PLANT NAME: H.B. Robinson # 2

H. B. ROBINSON UNIT NO. 2

INSULATION AND PIPING AFFECTED BY FAILURE
OF "C" REACTOR COOLANT PUMP SEAL, MAY 2, 1975 FOLLOW-UP REPORT

GRAPH 1

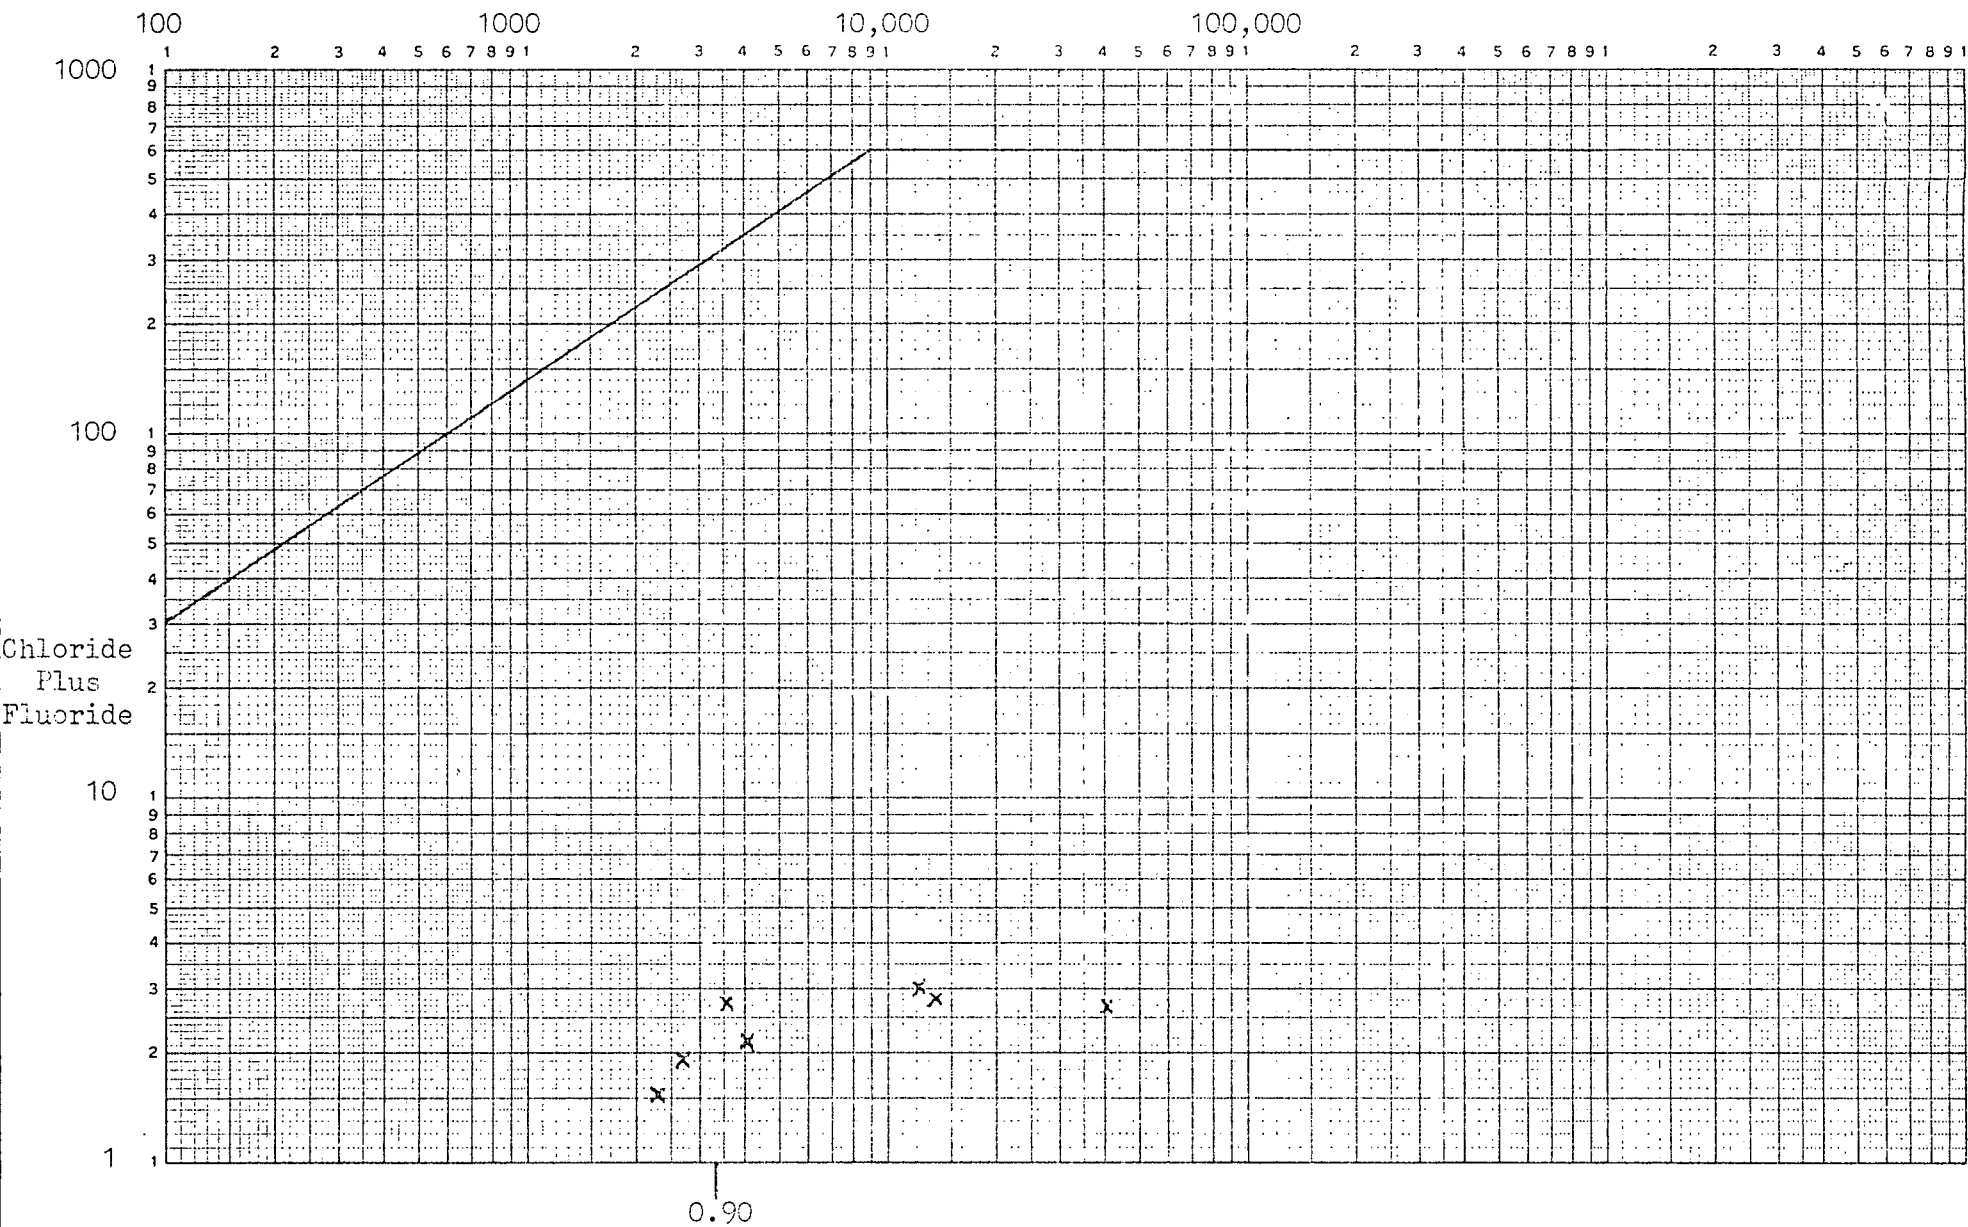
Graphs 1 and 2 of Mr. Utley's letter do not specify units used for plotting the curves and respective data.

Corrected Tables I and II from the Westinghouse Electric Corporation letter CPS-75-078 of June 3, 1975 and Table 2 from the Carolina Power & Light Company letter of June 13, 1975 are enclosed. Also a corrected Graph 1 is included to correspond with the corrected data in the tables mentioned above.

The units (PPM) used for plotting the curves and respective data on Graphs 1 and 2 are the same as for Figure 1 shown in Regulatory Guide 1.36.

LINE DIAGRAM 3

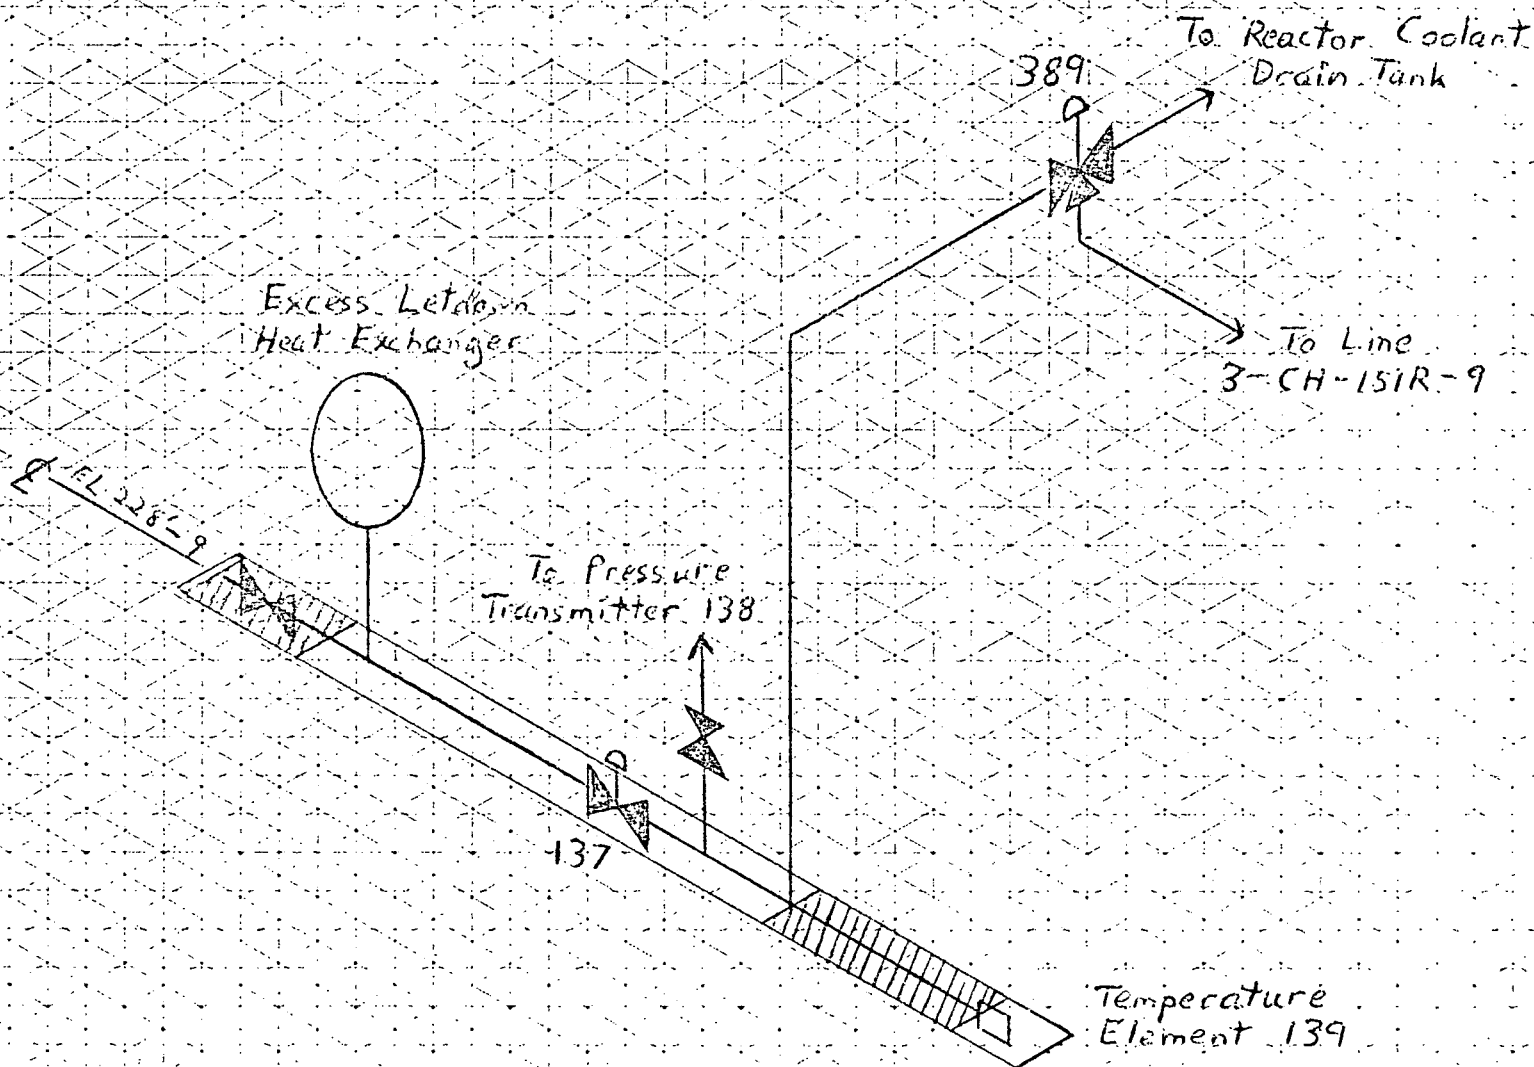
Charts showing the field location of the sampled piping insulation are illegible.

Drawings are attached which more clearly indicate the affected pipe and insulation.
